Technical Service Bulletin: tsb101277

Released Date: 26-Aug-2003

New Oversize Head Gasket

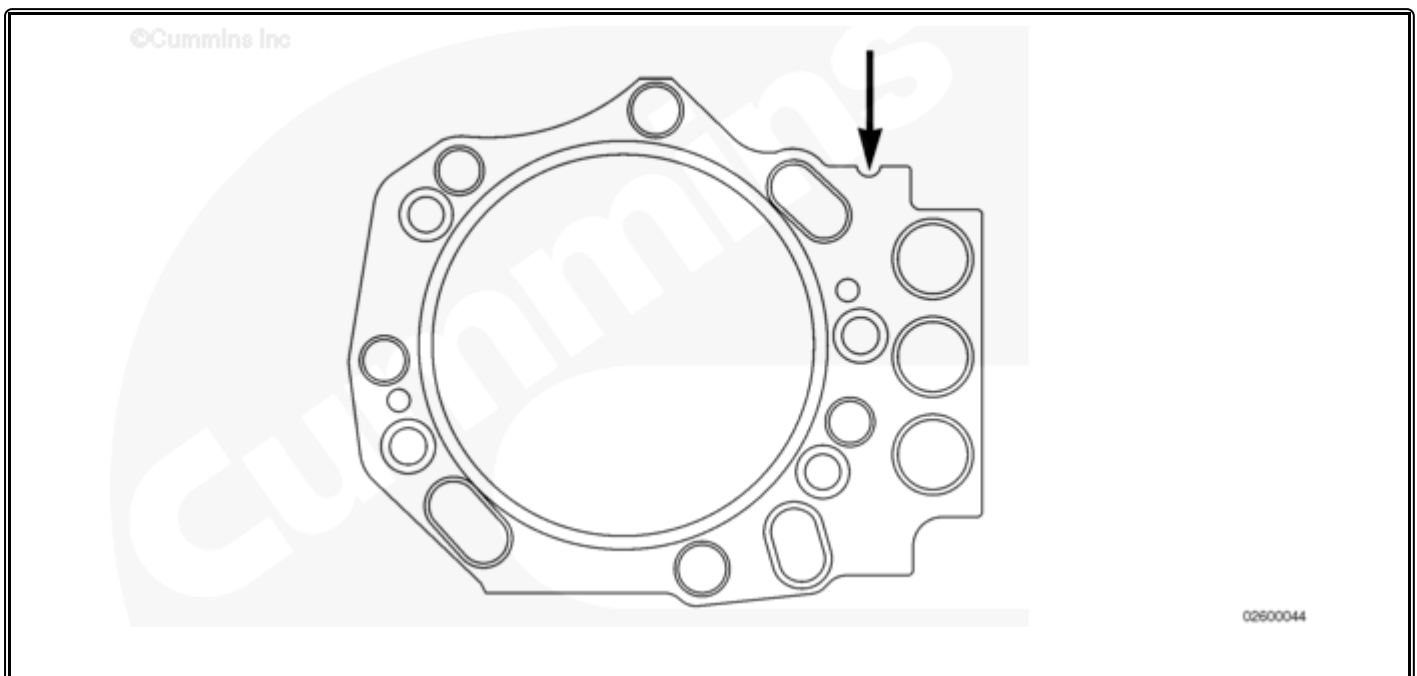
This service/parts topic introduces a new oversize head gasket and wear limits for the cylinder block head deck of the QSK45 and QSK60 engines. The new cylinder head gasket, Part Number 4086730, has been released to allow the repair of worn cylinder blocks at engine rebuild/overhaul. The new gasket makes use of the same material and form as the existing gasket but is 0.51 mm [0.020 in] thicker. The gasket has a notch in the carrier to denote the gasket is a service oversize gasket, see the illustration above.

02600045

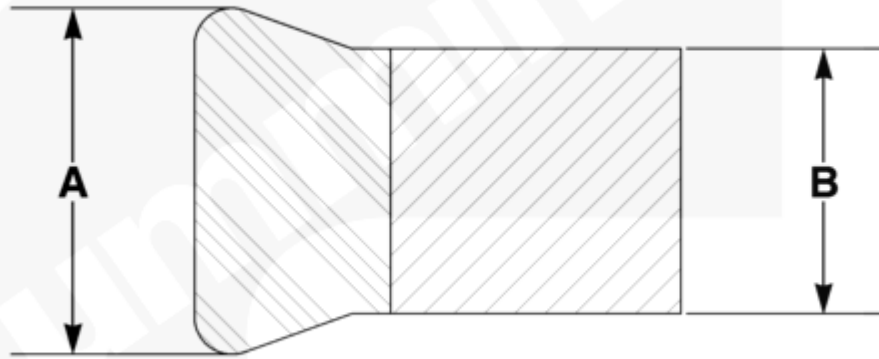
The illustration above shows the dimensions for the oversize gasket.

mm		in
3.12	MIN	0.123
3.48	MAX	0.137

mm		in
2.43	MIN	0.096
2.59	MAX	0.102
